ISSUE: Certificate of Appropriateness for alterations

LOCATION: Old and Historic Alexandria District
201 Gibbon Street

STAFF RECOMMENDATION

Staff recommends denial of the Certificate of Appropriateness for the replacement of the existing windows.

Figure 1: Proposed modifications to 201 Gibbon Street

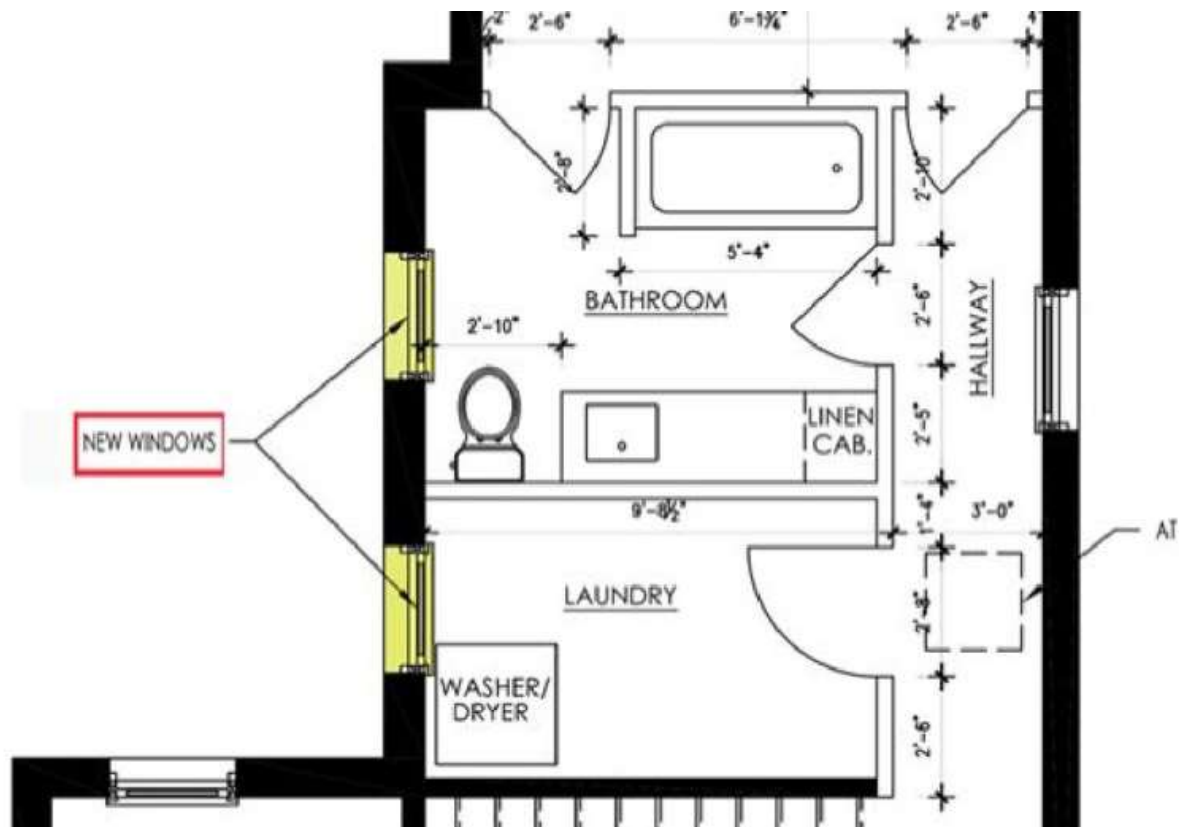
The applicant requests a Certificate of Appropriateness to replace two second floor windows (Figure 1); removal of chimney was previously approved.

Staff appreciate the efforts of the applicant to more fully document the history of the structure at 201 Gibbon Street with a particular focus on the two windows being proposed to be replaced. While these windows do not appear to date from the original construction of the structure and have been modified over the course of history, they have historic merit in their own right. Staff finds that consistent with the *Design Guidelines*, the existing windows are historic and should be retained in place and recommends denial of a Certificate of Appropriateness for their replacement.

Figure 3: 1951 drawings showing the relocation of the subject windows from the western exterior wall

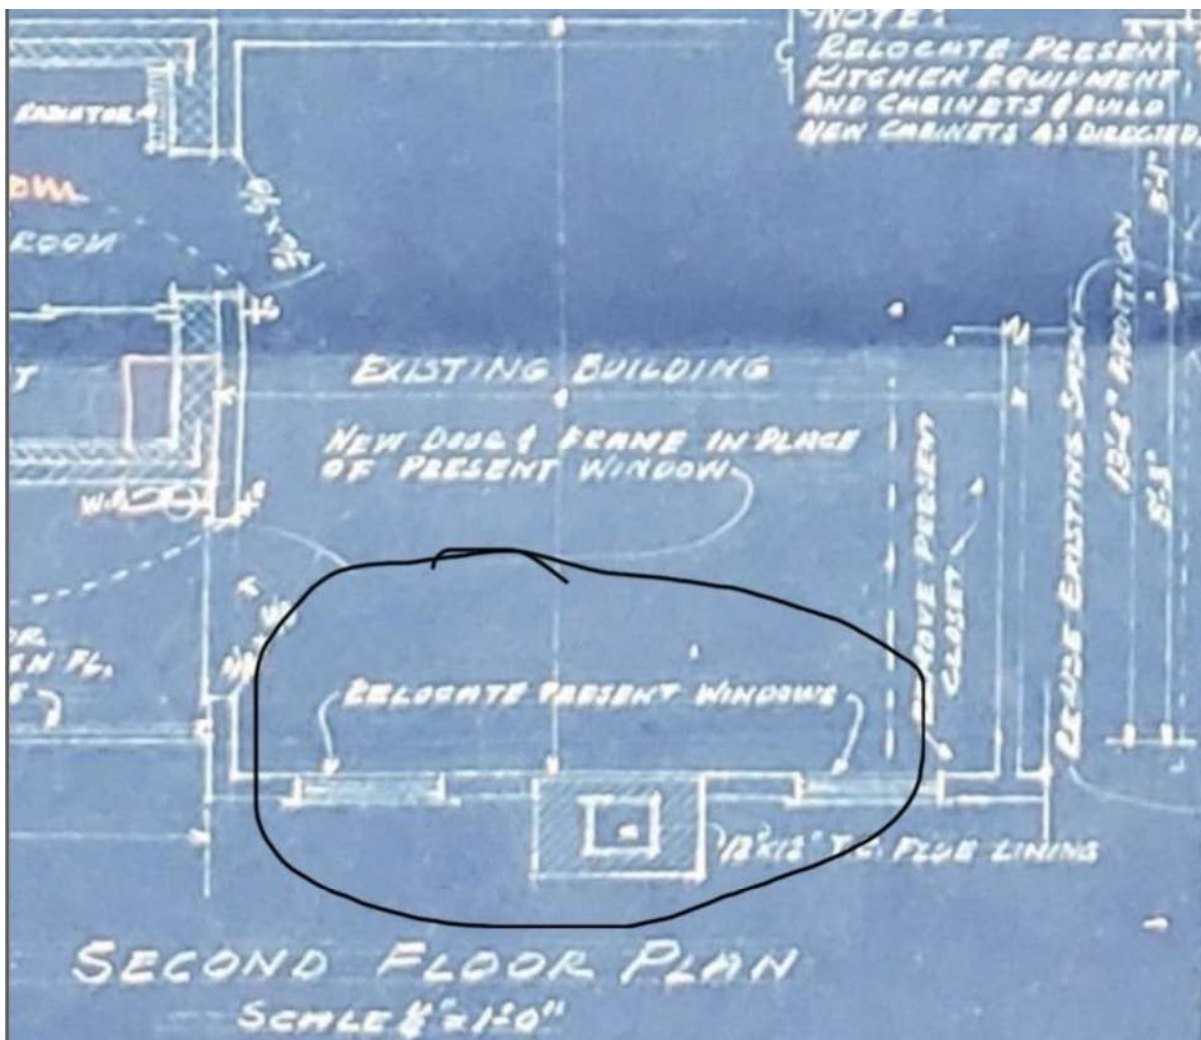
In 1951 the building underwent another addition, with a masonry wing added to the west side of the structure. The original blueprints from that addition show a new chimney being built on the southern exterior wall and include notes indicating that two windows located on the western exterior wall be relocated to the southern wall (Figure 3). In 1952, a memo was written to the City building inspector indicating that the location of the proposed chimney was to be changed to the interior of the building, not along the south wall.

This memo did not address the relocation of the windows, so it appears that the windows were relocated to their current location. Staff was able to observe the framing of the wall in this area from the inside of the structure because some of the interior finish has been removed. The wall framing in the area did not definitively indicate whether or not these windows had been relocated but the location of door openings in the adjacent western wall is consistent with the 1951 drawings. With these factors, it appears likely that the subject windows are not currently located in their original locations.
